As discussed recently on the phone I wanted to add the OLS penetrations by each of the corners of the proposed University building onto the attached plan. As you can see the proposed building will penetrate what is called the Airports Conical Obstacle Limitation Surface OLS by amounts varying between 12.5m - 16.5m. The Conical surface is a sloping arc and the 51m, 60m and 70m AHD arcs are shown on the attached plan.

OLS SURFACE

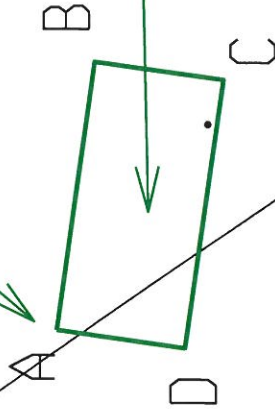
OLS	Heights at the 4 Building corners	
OLS Corner A=	60.24mAHD	penetrates by 15.26m
OLS Corner B=	63.0mAHD	penetrates by 12.5m
OLS Corner C=	61.8mAHD	penetrates by 13.7m
OLS Corner D=	59.0mAHD	penetrates by 16.5m
